Technical News Bulletin

Steinhausen, August 2019

Bezier Scoop Family for constant cone delivery

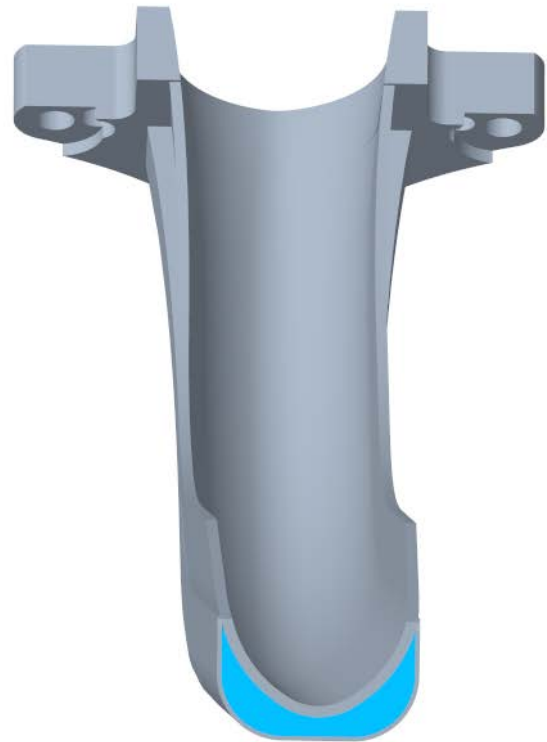
The introduction of a scoop family based on Bezier curves enriches the Bucher Emhart Glass scoop portfolio. The concept of applying a Bezier curve for the scoop design follows the same principle used for the Constant Cone Bezier Delivery where an optimized centrifugal force distribution contributes to enhanced gob loading.

The new Bezier scoops will gradually replace all the previous scoops.

The Bezier scoop design also includes a redesigned cooling chamber to guarantee optimal loading conditions.
